Appl. No. 10/790,844

Amdt. dated November 29, 2006

Reply to Office action of August 29, 2006

AMENDMENTS TO THE DRAWINGS:

Fig. 1

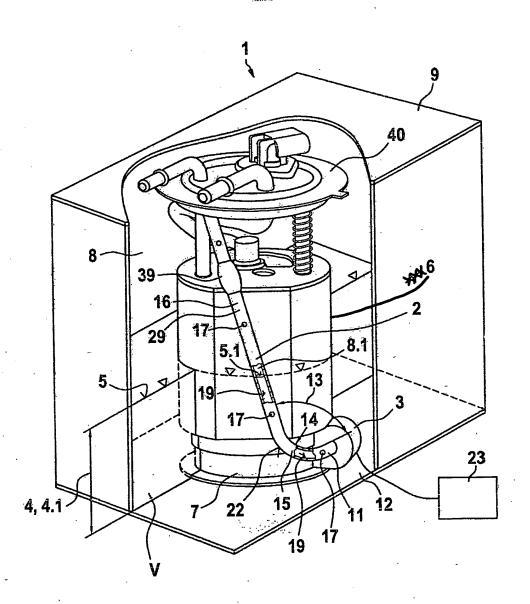
The two attached sheets of drawings include changes to Figs. 1 and 2 and replace the

on January 20, 2006. In Figs. 1 and 2, the arrow pointing from reference numeral 6 has been

extended to touch the fluid feeding device.

Both Figs. 1 and 2 have been amended to show the arrow pointing from reference

numeral 6 touching the fluid feeding device, as suggested by the examiner.
